Subject: SEP Topic III-6, Seismic Design Considerations
Reactor-Turbine Building Complex

NRC Docket 50-237

In response to Tom Cheng's request of May 14, 1981 the following information was developed by URS/John A. Blume.

FIGURE 1 THREE-DIMENSIONAL LLL DYNAMIC MODEL OF THE REACTOR-TURBINE BUILDING COMPLEX, DRESDEN NUCLEAR POWER STATION, UNIT 2

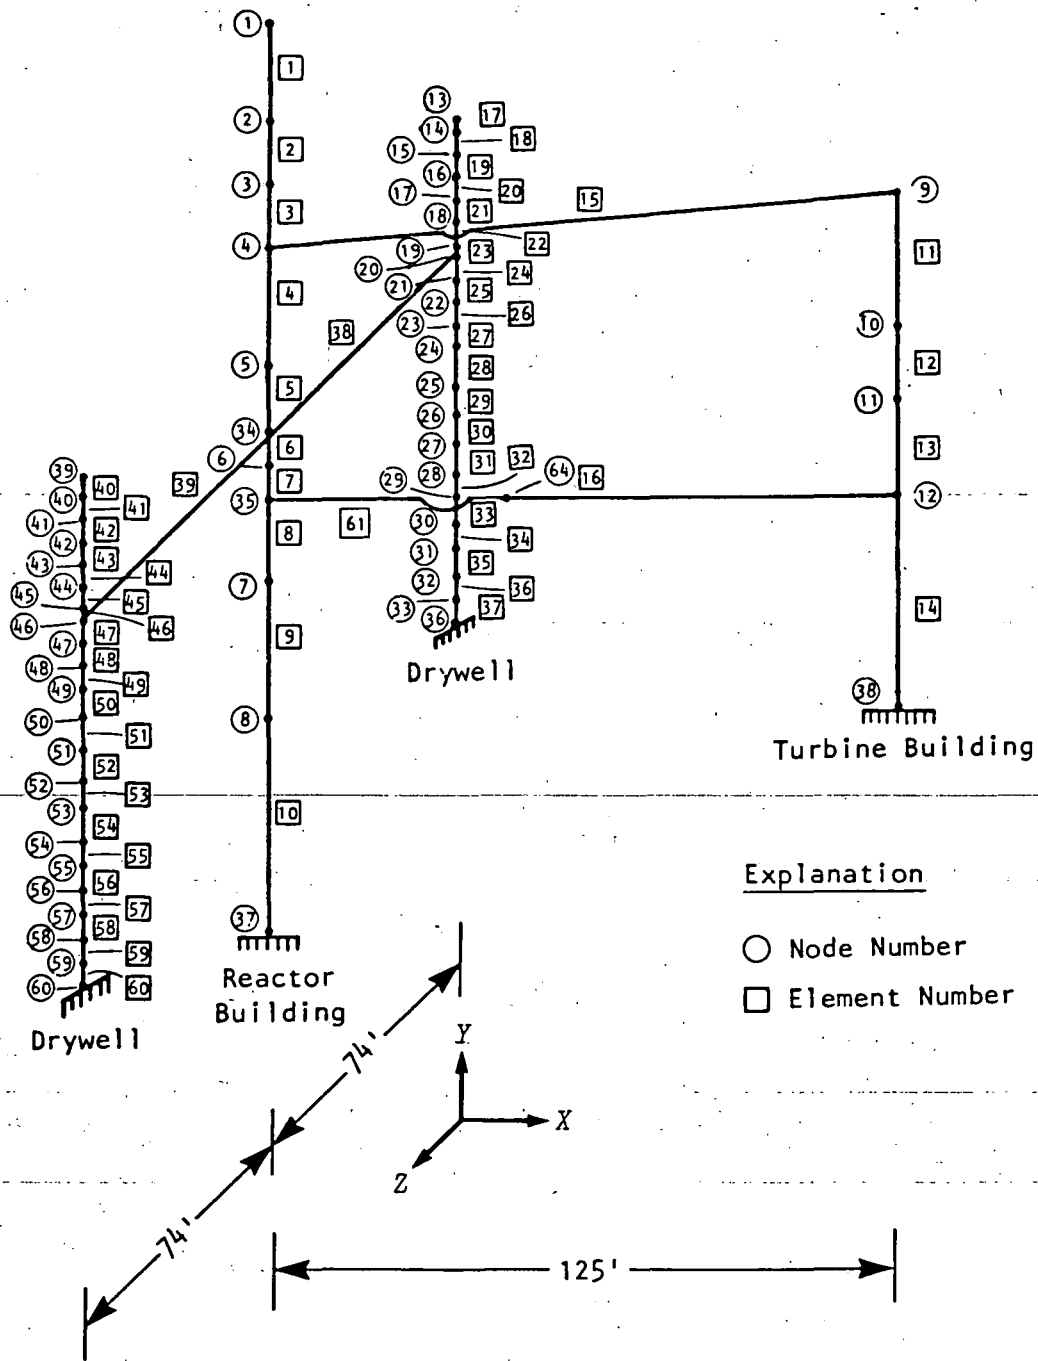
For their review of Dresden 2, the Lawrence Livermore Laboratory (LLL) developed a three-dimensional reactor-turbine building complex (RTBC) dynamic model for the orthogonal horizontal directions. This model is shown in Figure 1. The element stiffnesses and nodal masses of the model were modified by URS/Blume in an earlier study to reflect more accurately the as-built conditions, and the modified model was used to analyze the RTBC for the east-west component of ground motion. URS/Blume has used this same modified model to analyze the RTBC for the north-south component of ground motion.

Table 3 gives a comparison of axial forces in the roof level diaphragm and the operating floor level diaphragm obtained by the two analyses. The axial force calculated for the operating floor level diaphragm in the URS/Blume analysis is about five times larger than that calculated in the LLL analysis. This increase in axial force is attributed to the increased stiffness of the lowest story of the turbine building.

FIGURE 2 COMPARISON OF FLOOR RESPONSE SPECTRA, NORTH-SOUTH COMPONENT OF GROUND MOTION, NODE 5, EL 589 FT, REACTOR BUILDING, DRESDEN NUCLEAR POWER STATION, UNIT 2

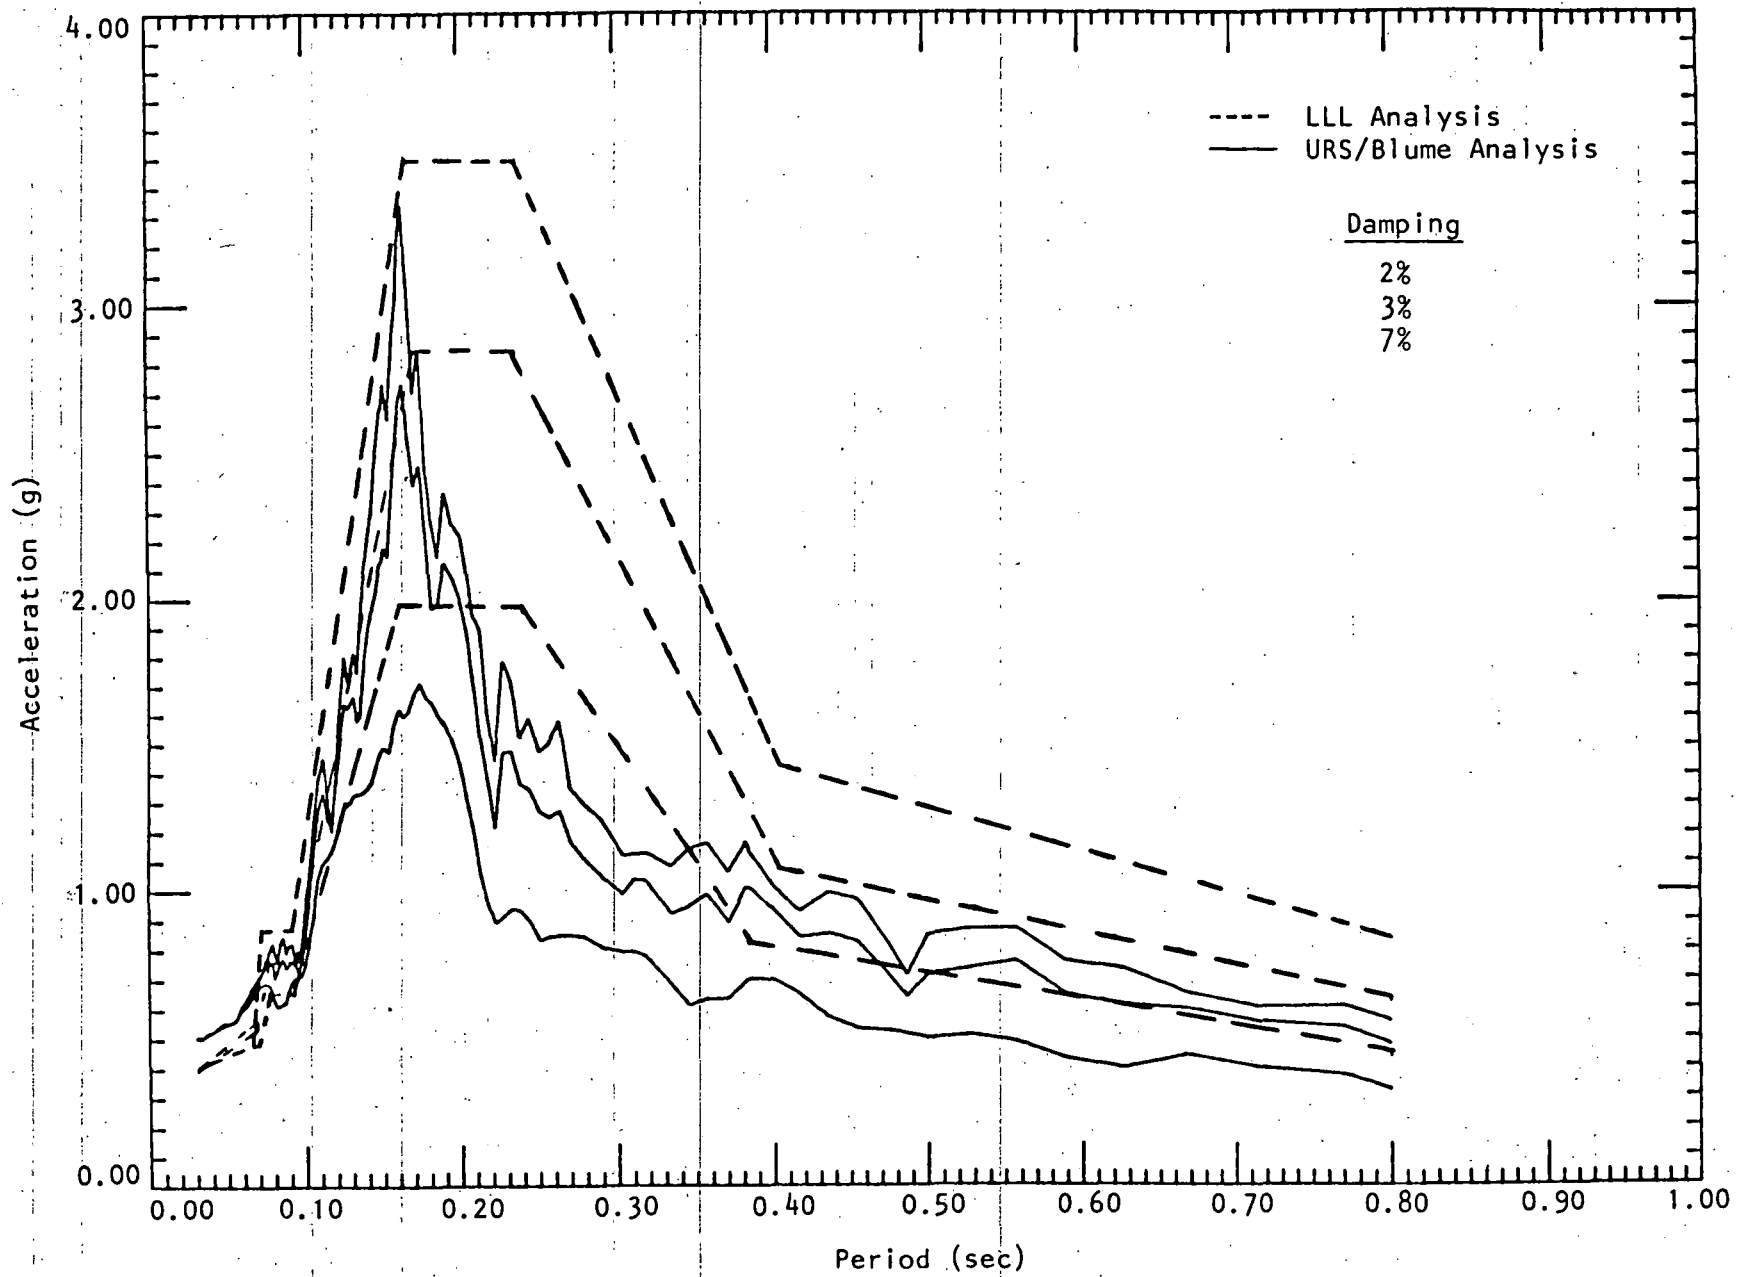
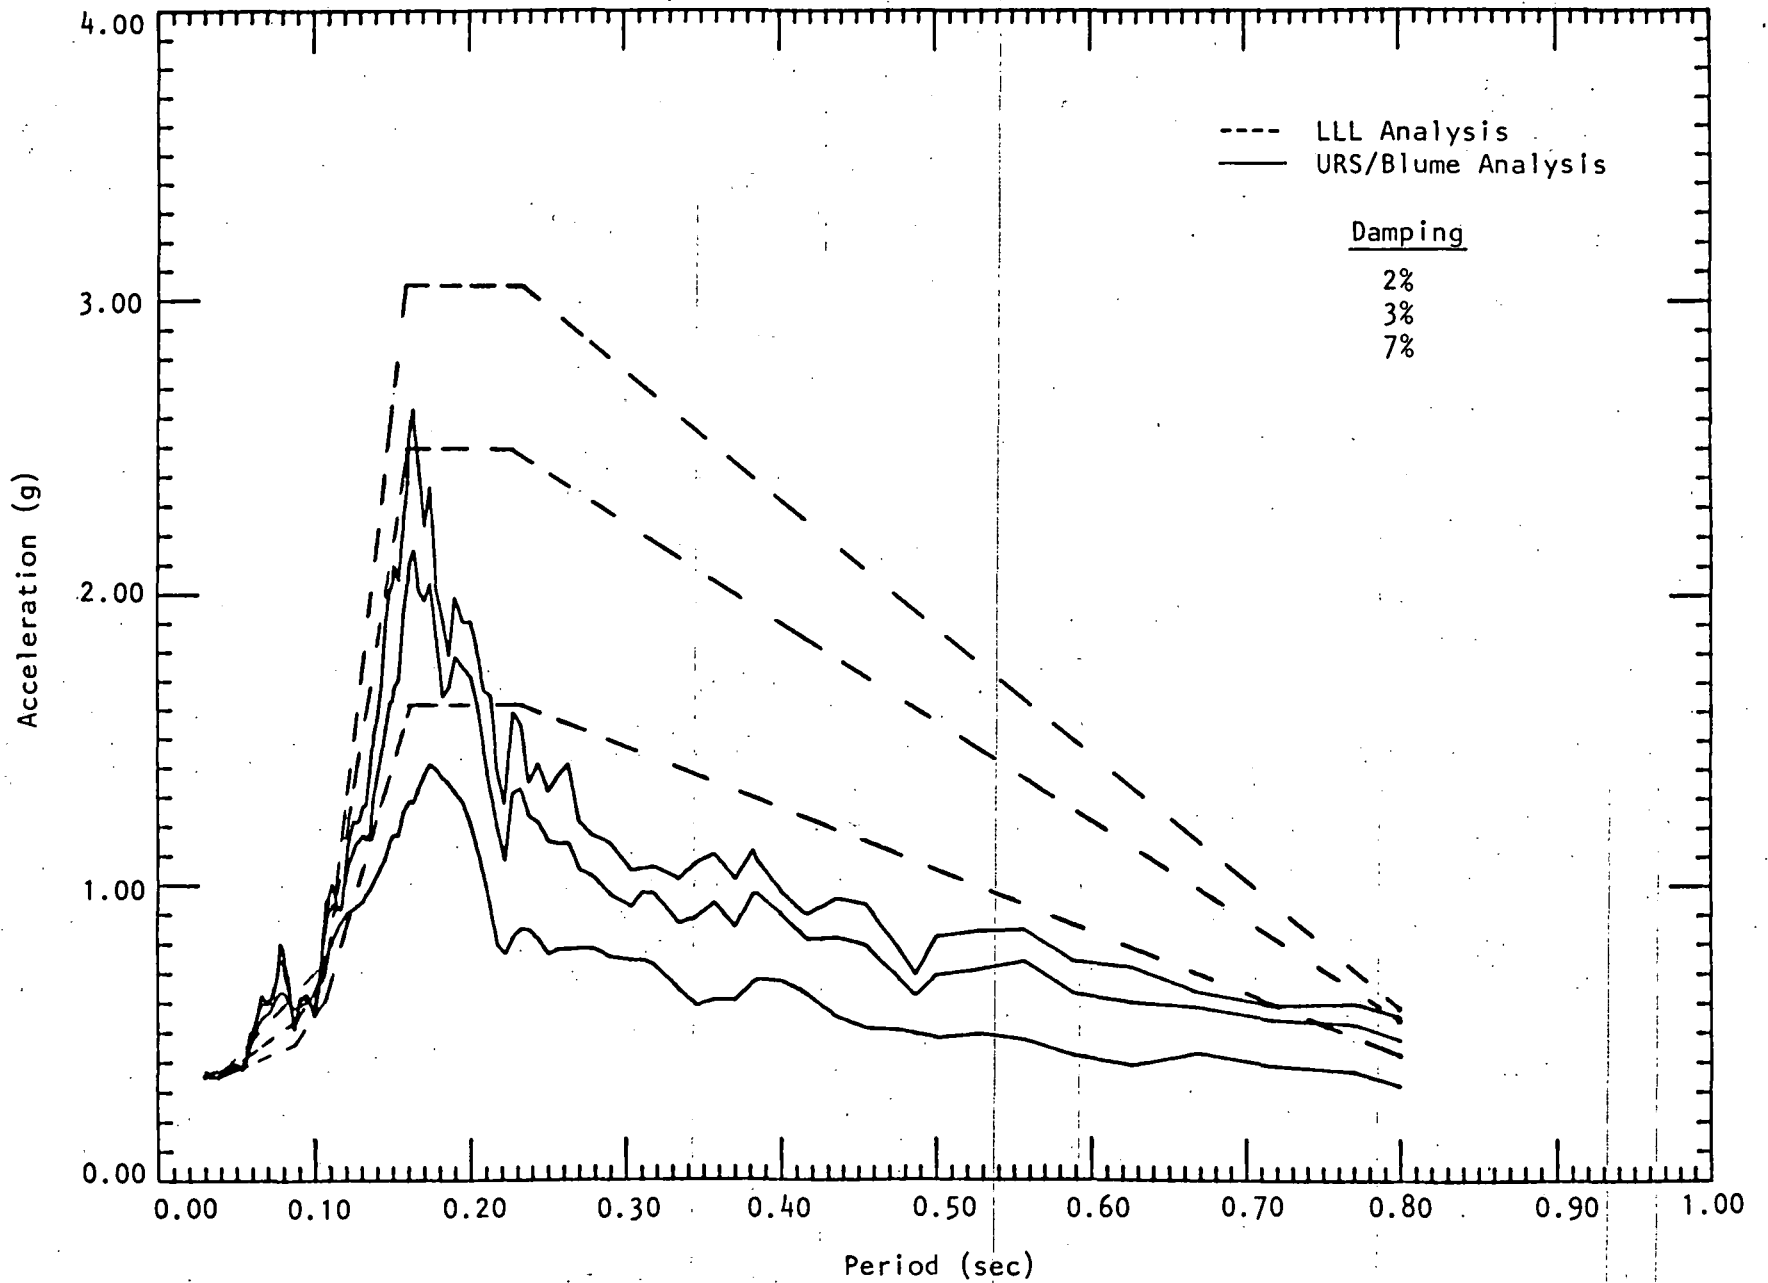
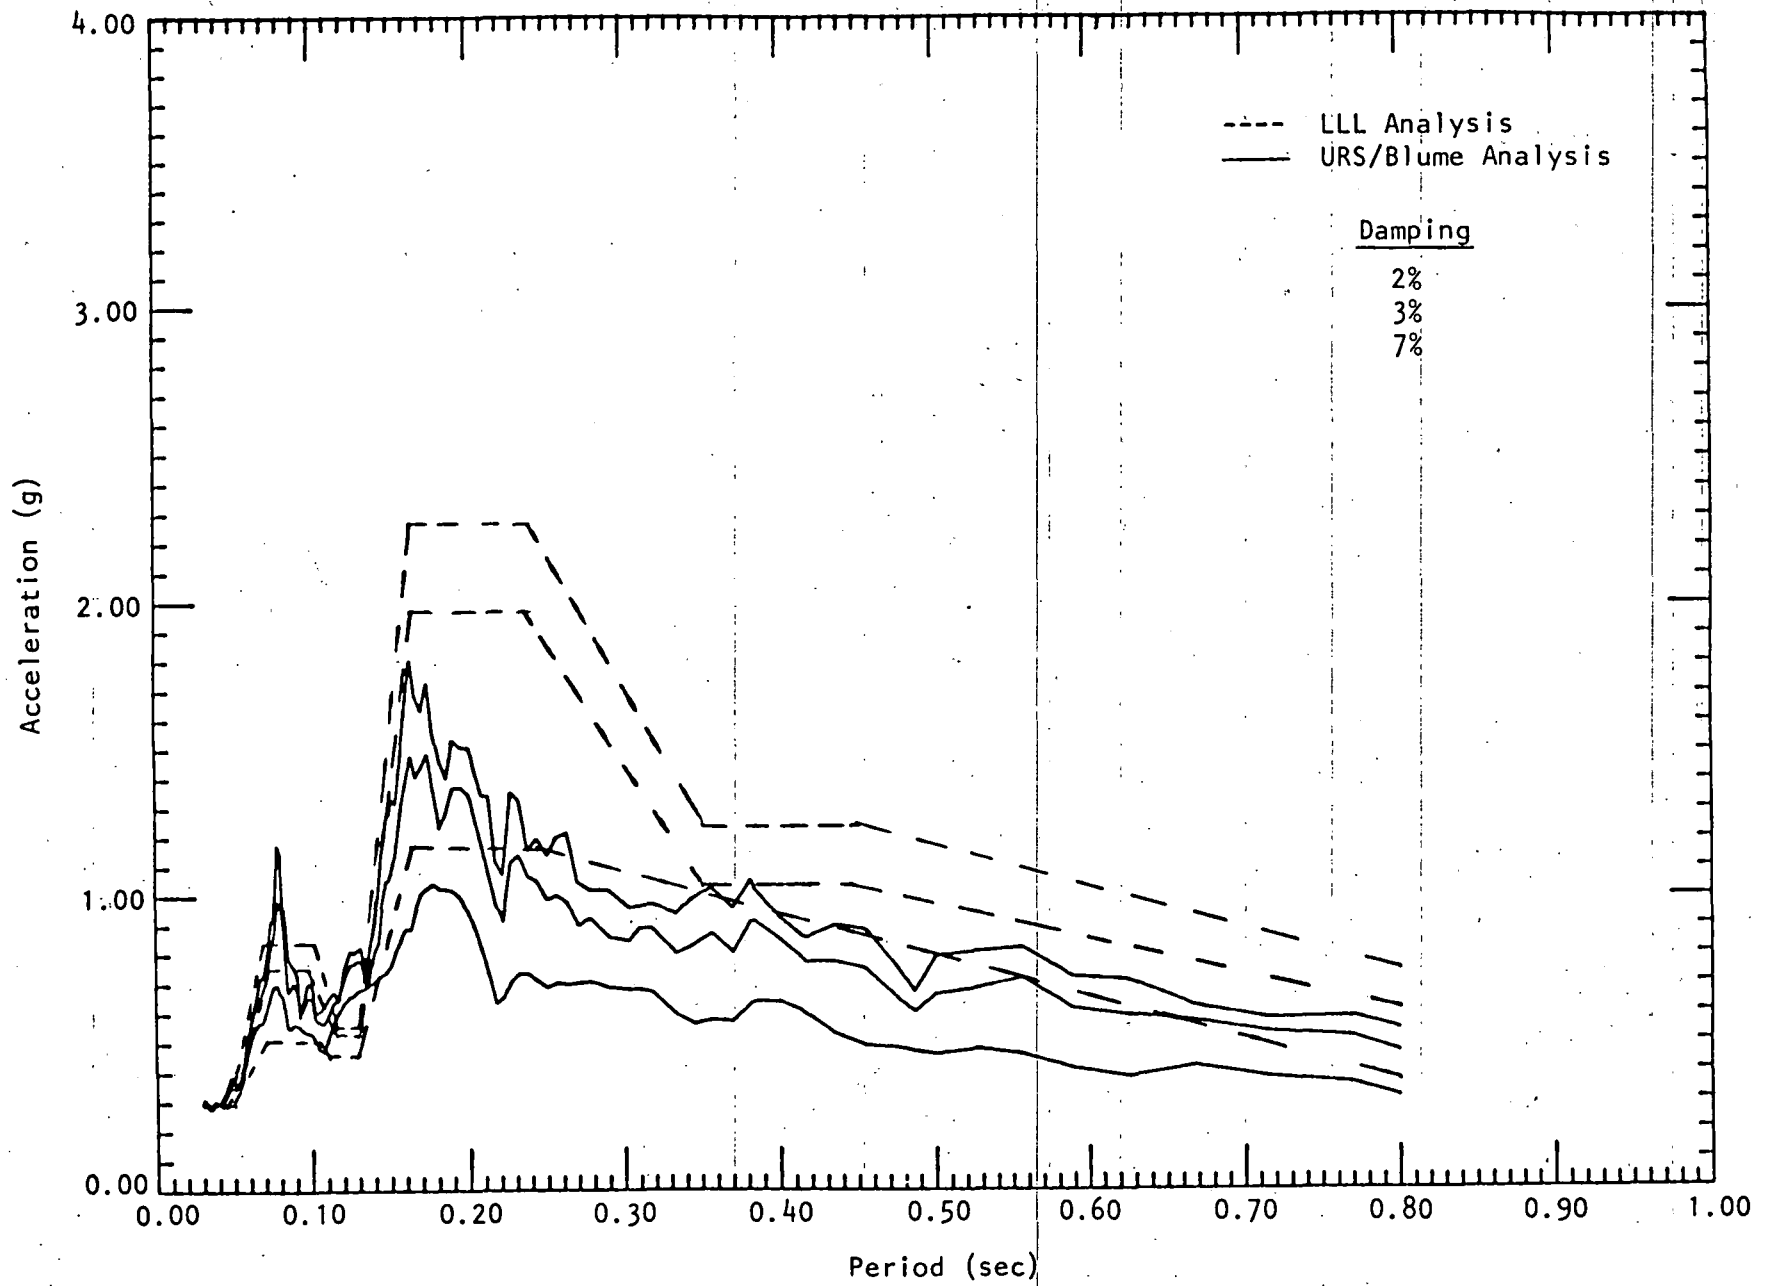
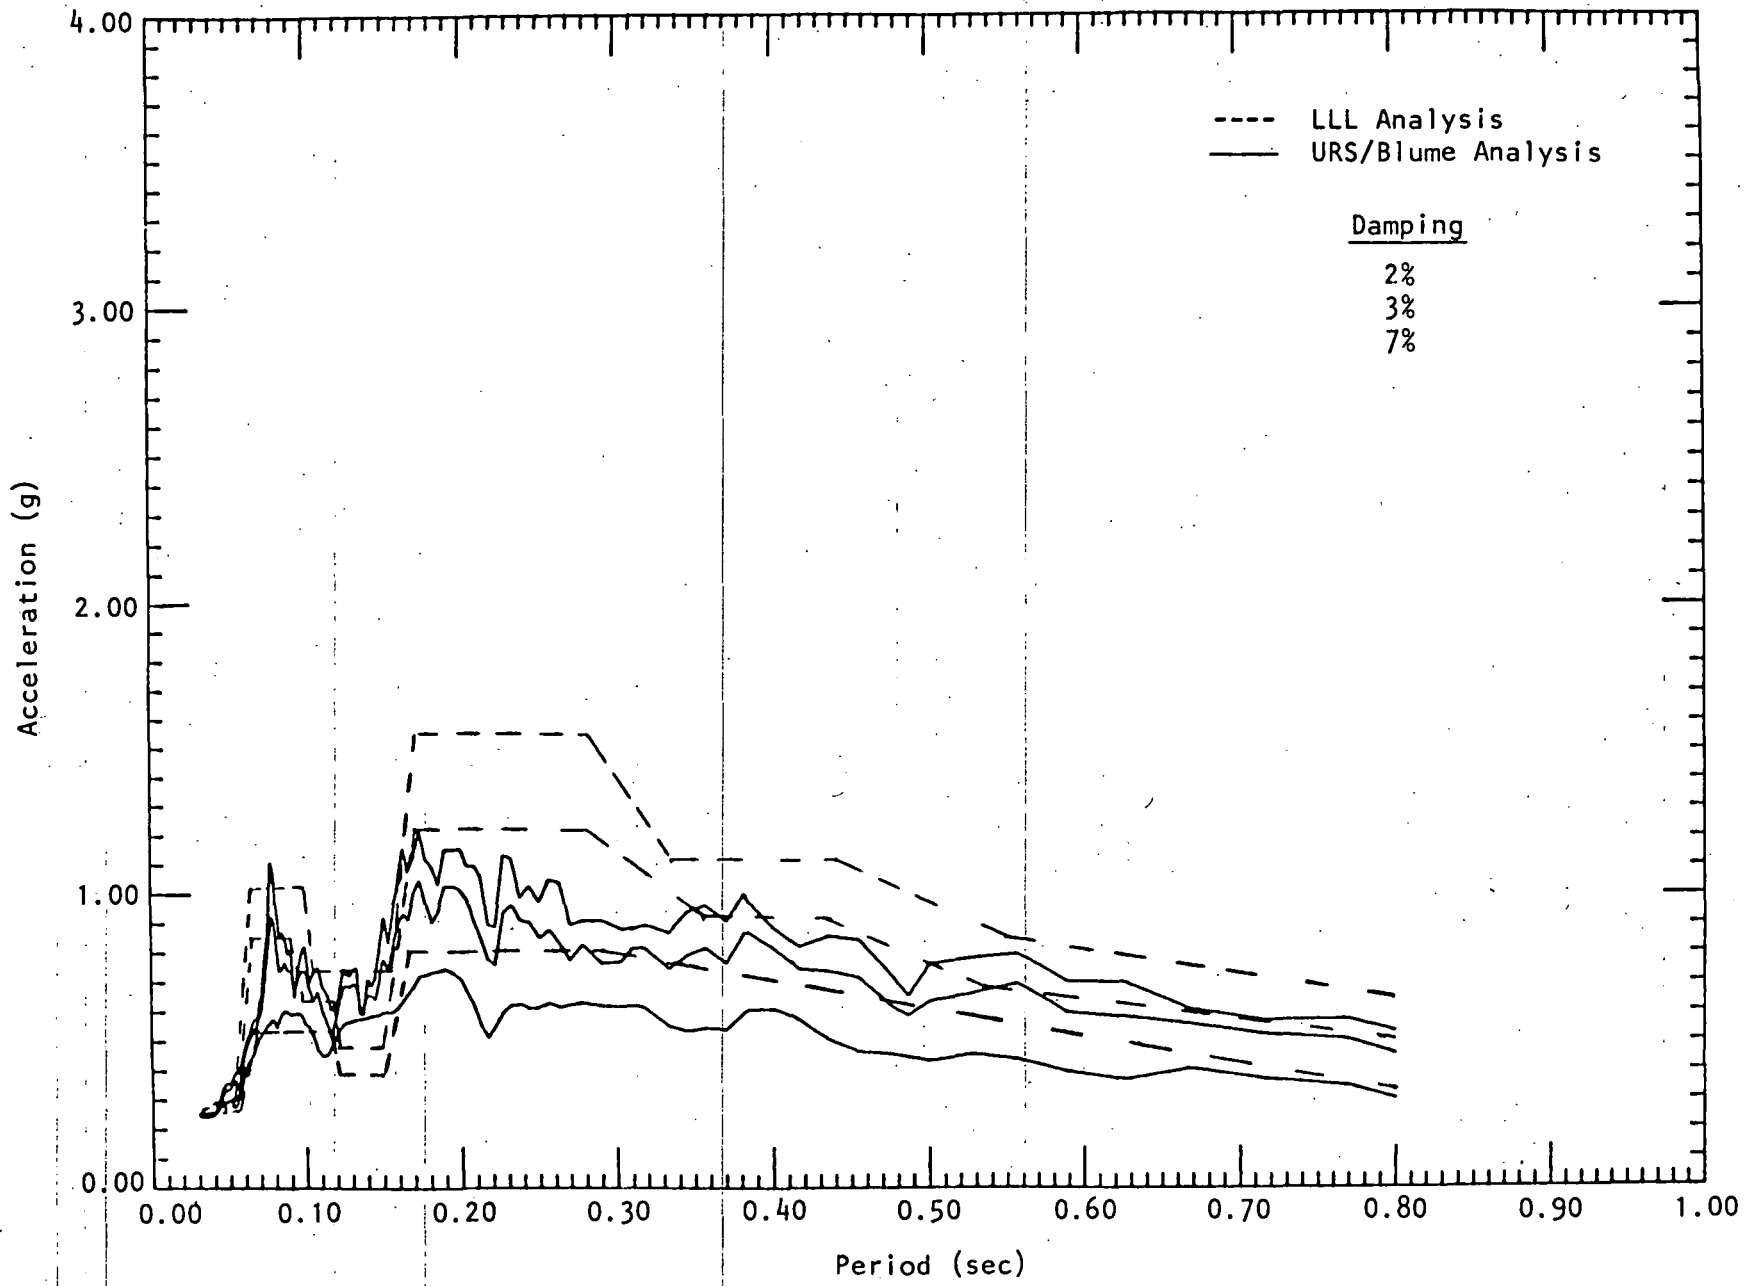
Figures 2 through 5 give comparison of the broadened and smoothed floor response spectra calculated by LLL (as presented in NUREG/CR-0891, Figures 5-12, 5-14, 5-16, and 5-18) with the raw floor response spectra calculated in the present URS/Blume analysis. The spectra calculated in the URS/Blume analysis are, in general, lower than those obtained in the LLL analysis except at the higher structural frequencies where the peaks as calculated by URS/Blume are higher than those calculated by LLL. The figures also show a frequency shift of the peaks of the spectra. The frequency shift is within the broadened portion of the LLL spectra and as such is covered by the 15% peak broadening procedure.
